Building 86

Building Code Evaluation for Building 86
Romberg Tiburon Center
Tiburon, CA 94920

Prepared on: August 3, 2015

Code review of existing structure Building 86 at SFSU Campus Tiburon

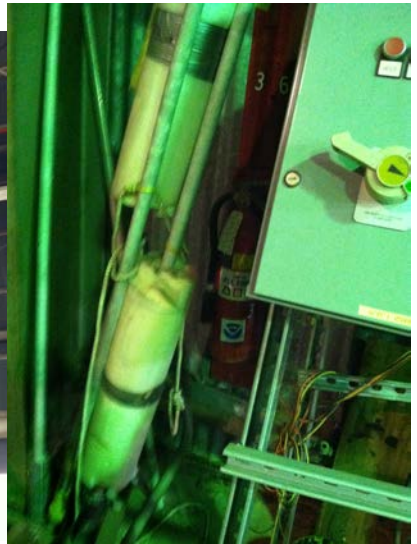
To my right as I enter from the north are new walls of unknown construction. They appear to be 2x6 with ½" sheetrock. Their insulation status is unknown. The walls are approximately 6-3/4" thick & 97-1/4" tall. These walls are unsupported and have no ceiling. These walls were not observed during construction and as such, I cannot determine or verify anchorage, nailing or material. The new wall construction creates a single room with a wood floor and an improperly installed electrical box in the center. There are many electrical boxes located through out the interior side and exterior side of these new walls. They are filled with conductors, are unidentified and not safed-off.

I am unable to verify, due to limited time and access, if the structure is sound. It will not meet code application for seismic compliance under Section 34 referenced above without modification. It appears, however, that all columns and beams are positively attached and show no signs of deformation, deterioration or degradation due to rust, seismic activity or physical impact. The posts are anchored to footings independent of the slab on grade. A structural engineer shall determine if this facility meets the criteria for seismic resistance per Title 24, CBC Chapter 34. This is my initial assessment, based upon my observations without benefit of testing or engineering calculations and design.

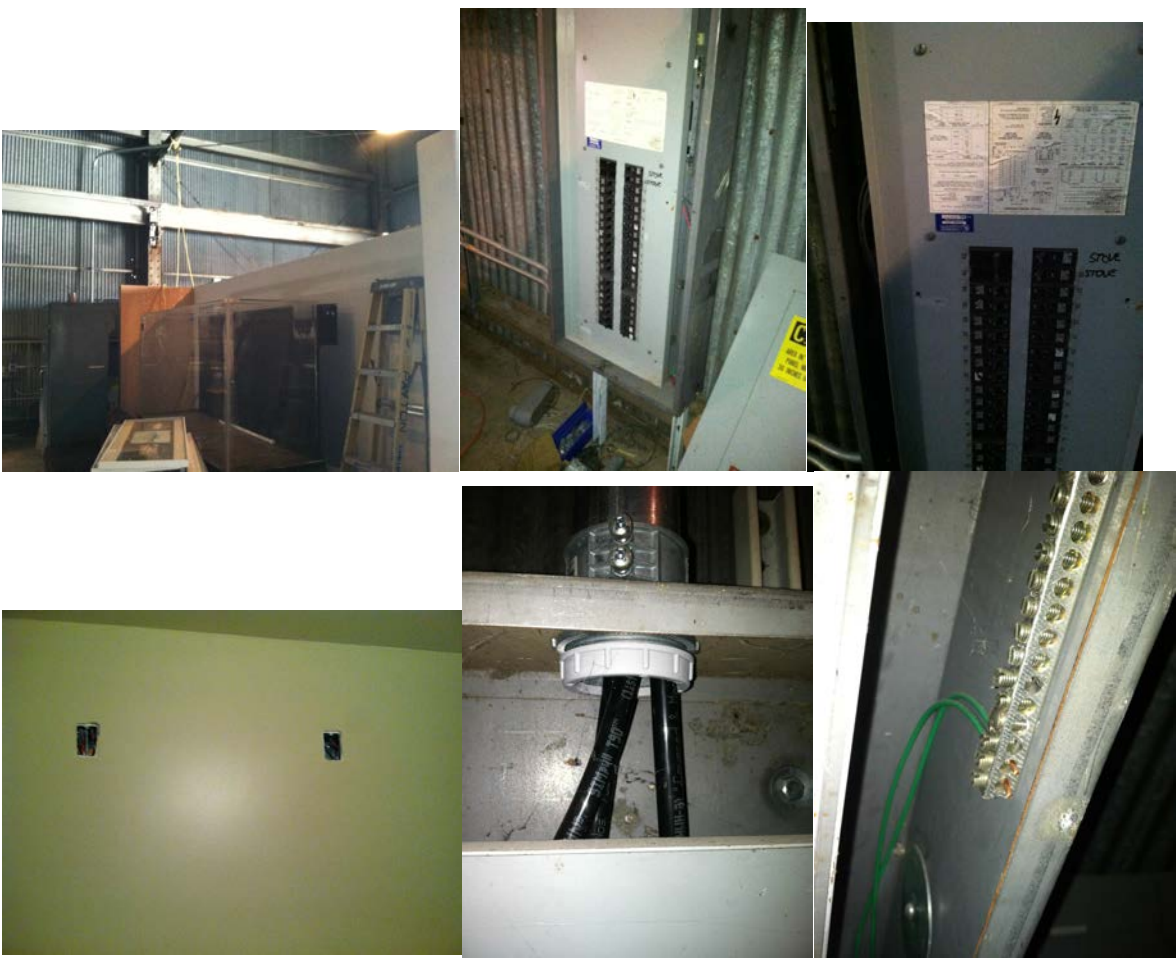
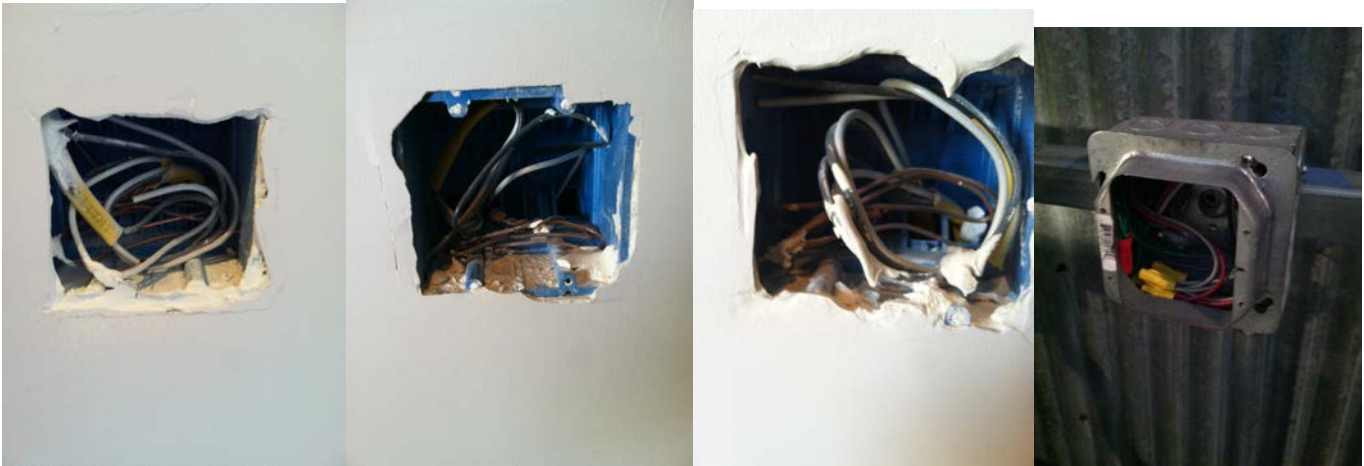
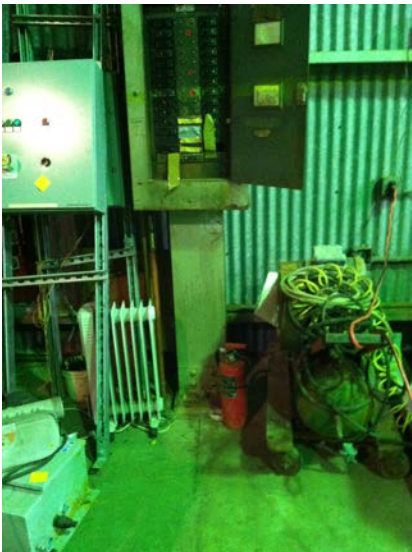
1. Junction boxes are unsafe/not safed off. 110.27
2. There are multiple electrical panels around the structure. One such panel is located to the right just past the newly constructed walls on the west wall exterior see picture. This panel seems to be a sub distribution panel pulling electricity from a newly installed main distribution panel above the existing office space. This panel is not properly bonded or grounded, article 250 et al,

3. is open to access, 110.27
4. does not have sufficient clearance 110.26 and
5. is installed upside down 110.12.
6. The MAIN panel newly installed is unidentifiable due to access limitations, 110.26 and

7. I cannot verify proper grounding and bonding. 110.8 , 210.3, 210.8, 250, et al.
8. Neither panel is labelled properly. 110.3
9. These panels do not meet the clearance requirements around the panel. 110.26

10. Front not installed or open breaker location-110.27
11. There are multiple junction boxes throughout the facility that are open exposing wires. 110.27

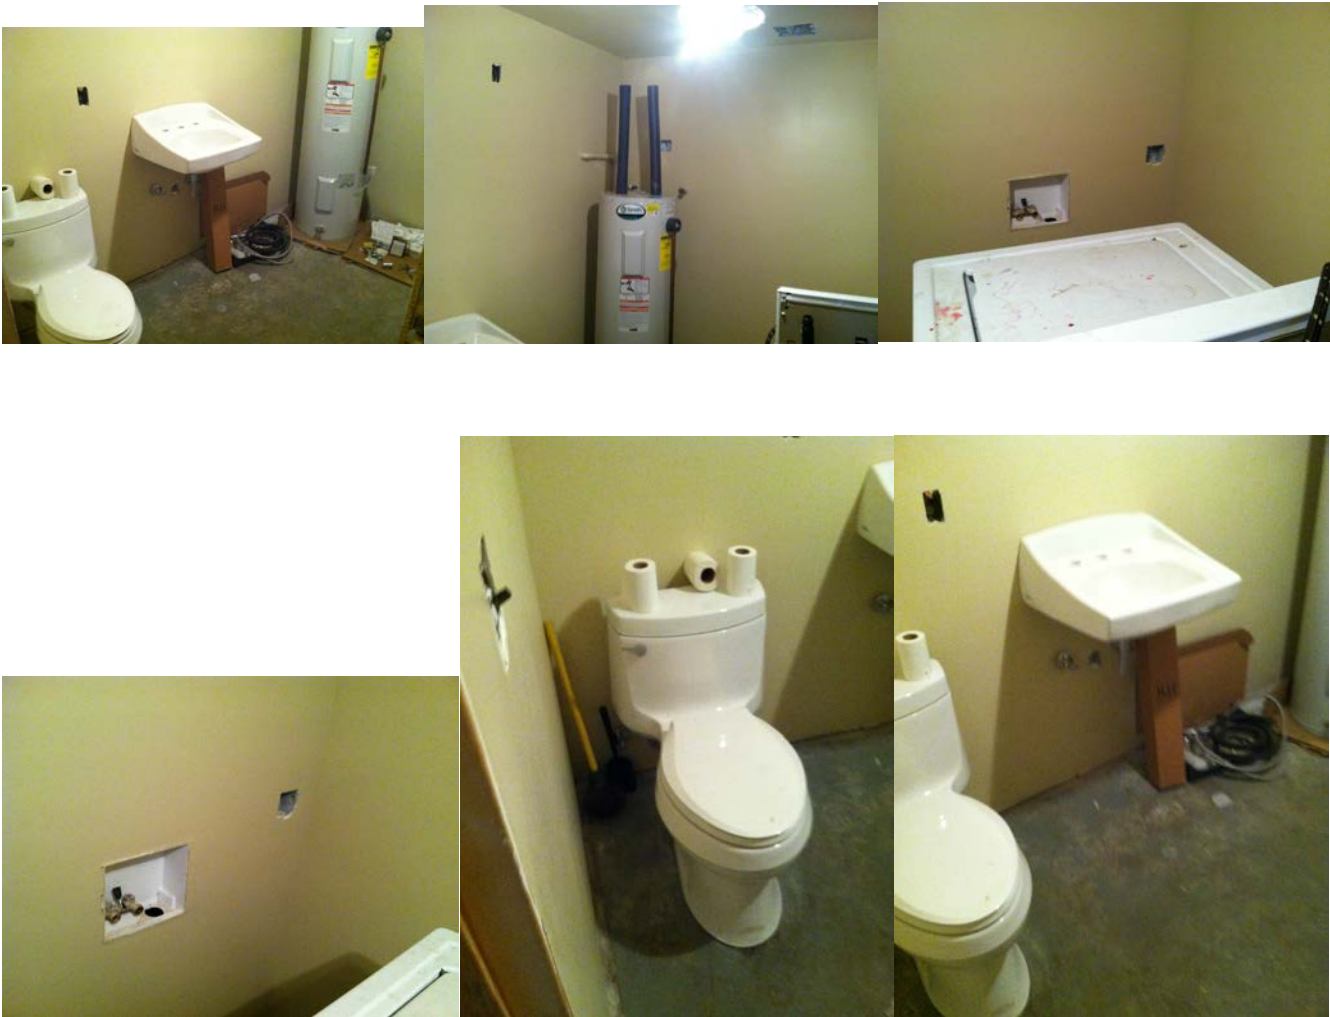
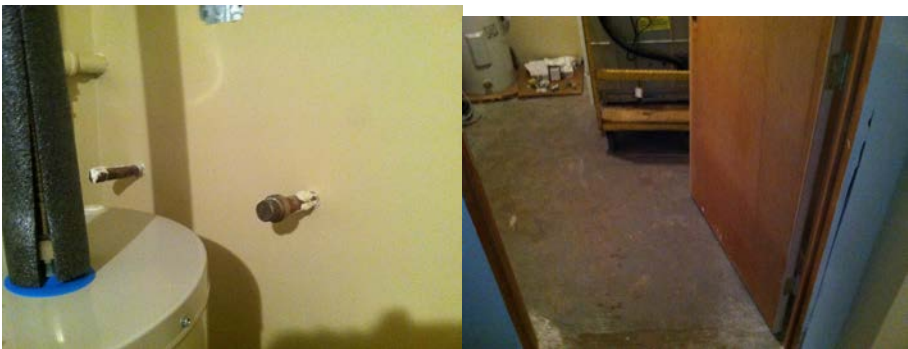
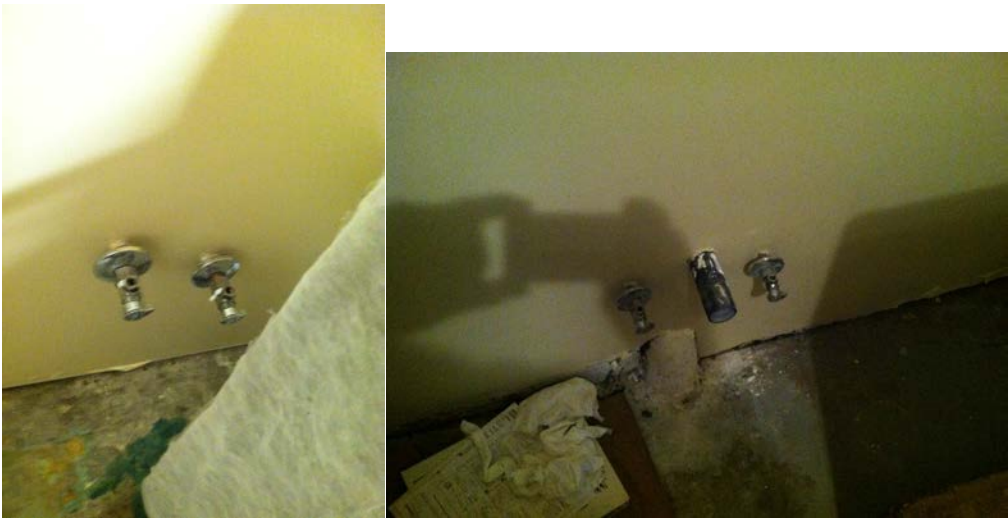
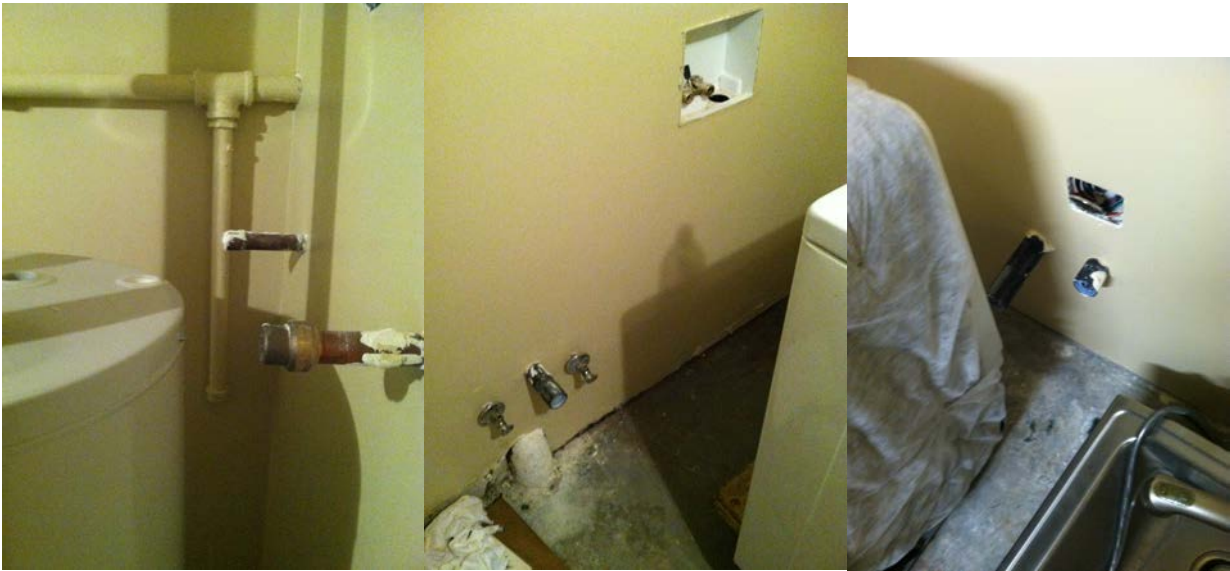
Someone began creating a bathroom on the left-hand side as I entered from the north.

1. The bathroom has no clean out. Cal Plumbing Code 707
2. The domestic water, waste and vent are unverified. Chapter 1 Cal Plumbing Code
3. The exhaust fan is not vented through the roof or to the exterior of the structure.
4. A hot water heater is being installed and the installation stopped. The hot water heater is to be installed per Chapter 5 of the Cal Plumbing Code.
5. Toilet is not Ch 11B CBC compliant in location, height or grab bars
6. Sink does not meet Ch 11B CBC
